Access Compliance Report Public Rights-of-Way (Curb Ramps)

Intersection ID: 24614 Main Street: BECKMORE_PL Cross Street: PINEVILLE-MATTHEWS_RD Location: NW

ADA ID: D61B3703F110 Ramp Type: Perp Initial Pass/Fail: Pass Overall Compliance: No Severity Score: 17.5

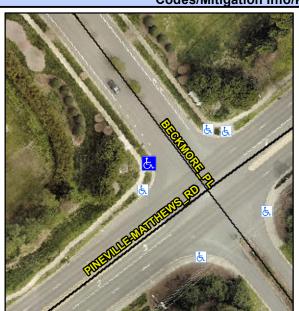
Not Found, R304.2.3, R305,
R304.5.4, R304.5.3

Field Measurements/Component Compliance						
Compliance Description		Data	Comp	liance Description	Data	
N/A	Ramp Length (in)	96.0	Yes	Ramp Slope (%)	5.5	
Yes	Ramp Width (in)	60.0	Yes	Ramp XSlope (%)	0.5	
N/A	Flare Type LT	Sloped	N/A	Flare Type RT	N/A	
N/A	Flare Slope LT (%)	10.5	Yes	Flare Slope RT (%)	9.3	
N/A	Flare Traversable LT?	Yes	N/A	Flare Traversable RT?	Yes	
Yes	Landing Length (in)	58.0	No	DWS Provided?	No	
Yes	Landing Width (in)	60.0	N/A	DWS Contrast?	No	
Yes	Landing Slope (%)	0.9	N/A	DWS Length (in)	N/A	
Yes	Landing X Slope (%)	1.5	N/A	DWS Full Width?	No	
N/A	Landing Curb? (Y/N)	No	N/A	DWS Offset (in)	N/A	
N/A	Shared Landing?	No				
Yes	Gutter Ponding?	No	No	Gutter Slope (%)	5.7	
Yes	Gutter Lip Ht (in)	0.0	No	Gutter X Slope (%)	2.9	
N/A	Painted X Walk1?	No	N/A	Painted X Walk2?	N/A	
	X Walk 1 Direction	To E		X Walk 2 Direction	N/A	
N/A	X Walk 1 Width (in)	N/A	N/A	X Walk 2 Width (in)	N/A	
	X Walk 1 Slope (%)	2.5		X Walk 2 Slope (%)	N/A

X Walk 1 X Slope (%)	0.7		X Walk 2 X Slope (%)	N/A	
N/A	Ramp inside XWalk1?	N/A	N/A	Ramp inside XWalk2?	N/A	
	Road Slope (%)	N/A	N/A	Clear Space?	Yes	
	Road X Slope (%)	N/A	N/A	Clear Space to XWalk (in)	N/A	
Yes	Any Obstructions?	No	Yes	Storm Grate/Utility Hazard?	No	
	Obstruction Type		l	Storm Grate/Utility Type		
		N/A			N/A	
			Yes	Surface Condition? (G/P)	Good

Remove & Replace Entire Ramp.
Remove & Replace Gutter.
